From: Hilary Saunders
Sent: 31 March 2016 13:06
To: Planning
Subject: Fwd: NYM/2016/0094/FL
Attachments: PD183-03-B.pdf, PD183-02-B.pdf

Please find attached revised drawings for your comment following your letter dated 15th March 2016 and our subsequent telephone conversation.

Job Title
PROPOSED REDEVELOPMENT OF
ROADSIDE FARM INCLUDING BARN
CONVERSION, NEW STABLE BLOCK
AND MENAGE

Drawing Number
PD183-02-B

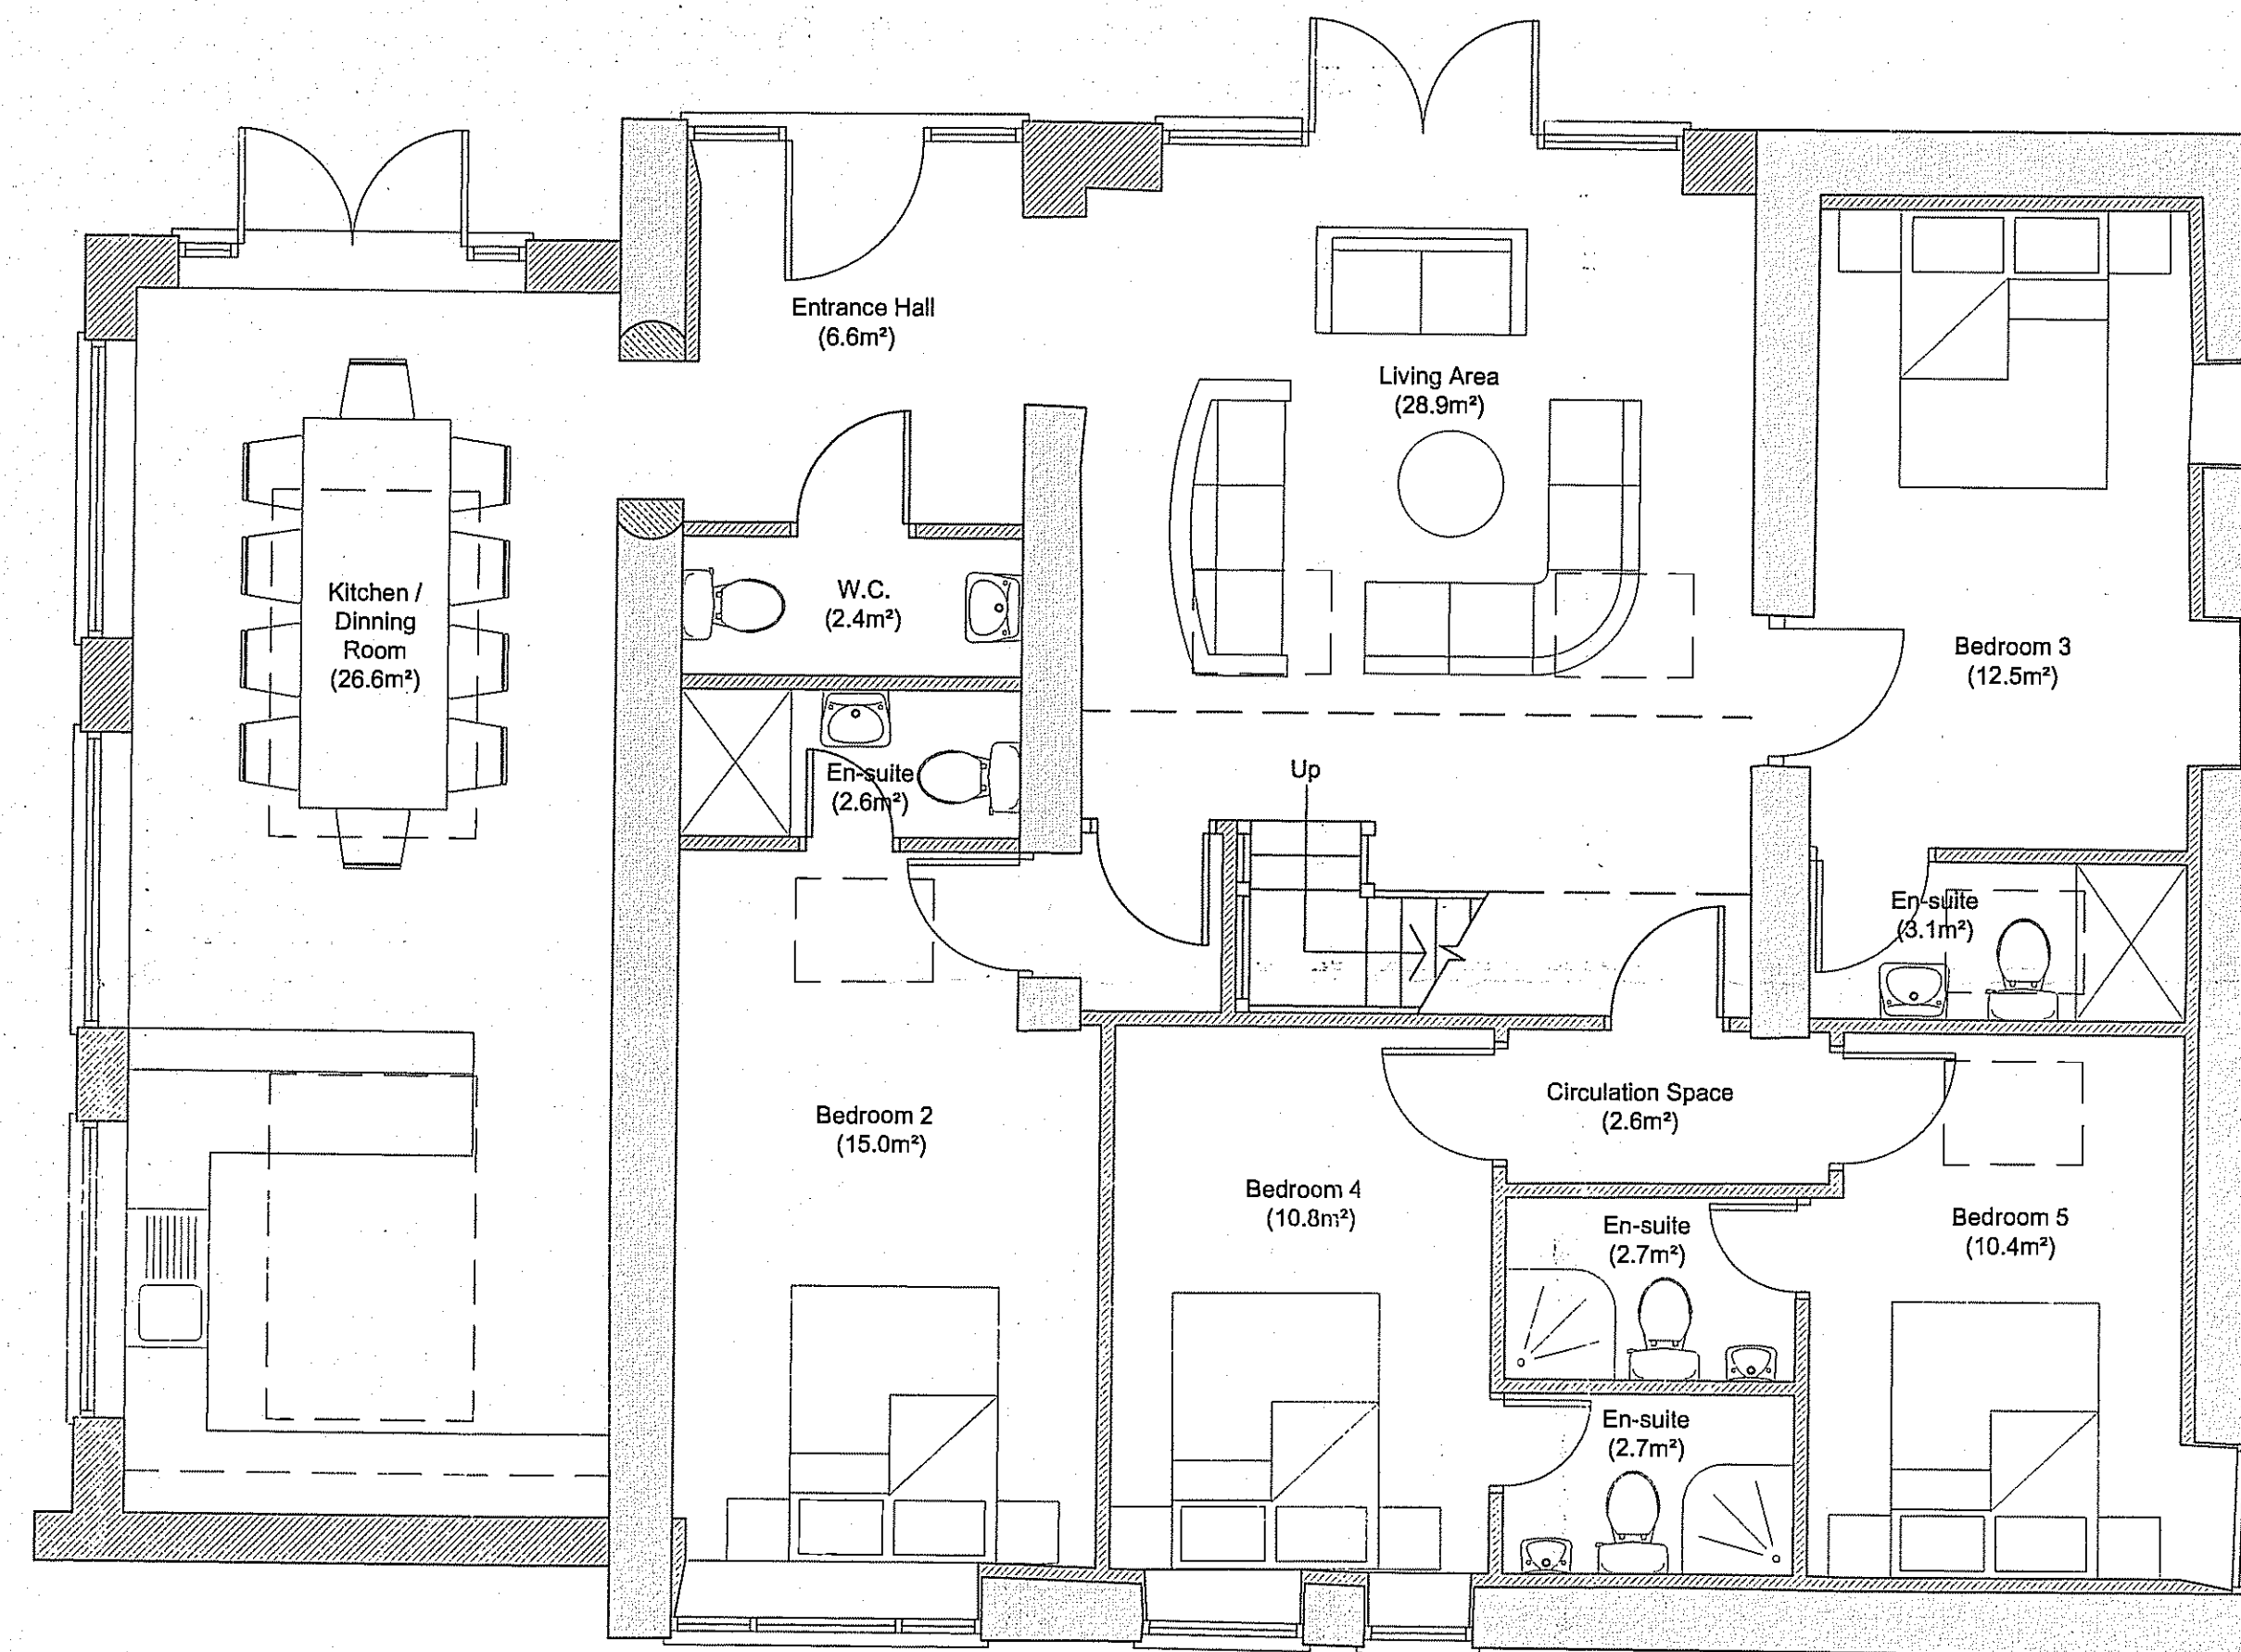
As discussed I have redesigned the proposed side extension to give it a more traditional look and reduced the amount of glazing. The elevations are of stone construction with traditional arched openings. I've included two roof lanterns in this scheme to give a feeling of height as I'm concerned about the head height available if we keep the extension below the eaves level of the existing barn. The roof lanterns are just visible on the West elevations (as drawn) but in practice with the ground sloping away to the west they won't be seen behind the proposed parapet wall.

I've also reduced the amount of rooflights in the western elevation to 3. I would prefer to retain this number as they will add valuable natural light to the scheme reducing the need for artificial lighting.

Drawing Number
PD183-03-B

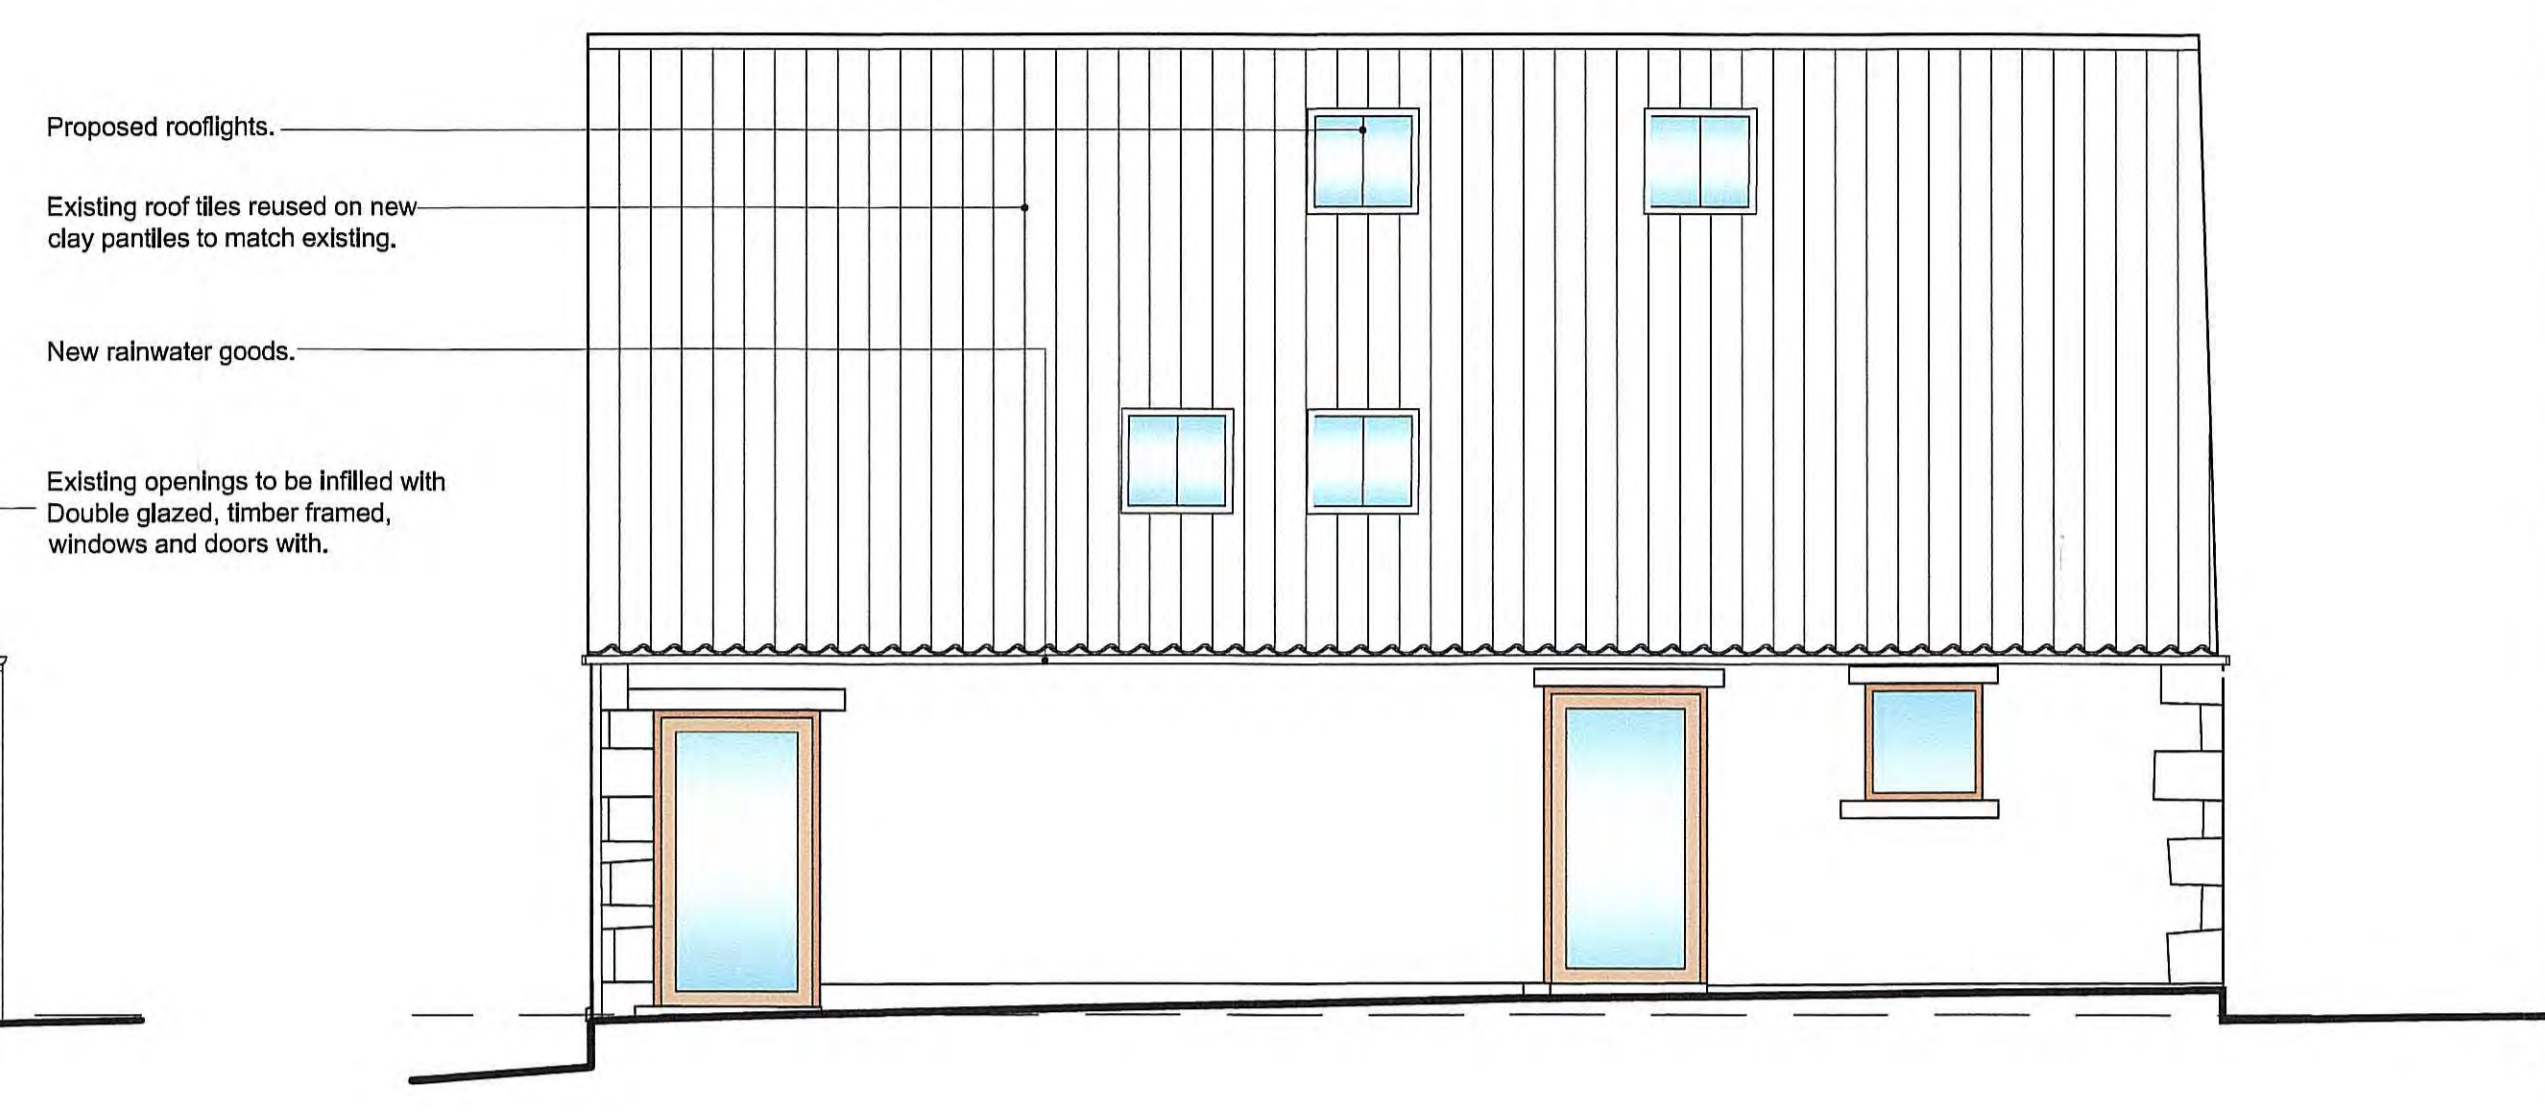
Could you please clarify your comments regarding the existing windows to the South elevation of the barn please? No new openings have been proposed and none of the openings have been increased in size. I've included for simple, rustic, oak frames infilled with glazing or timber panelling.
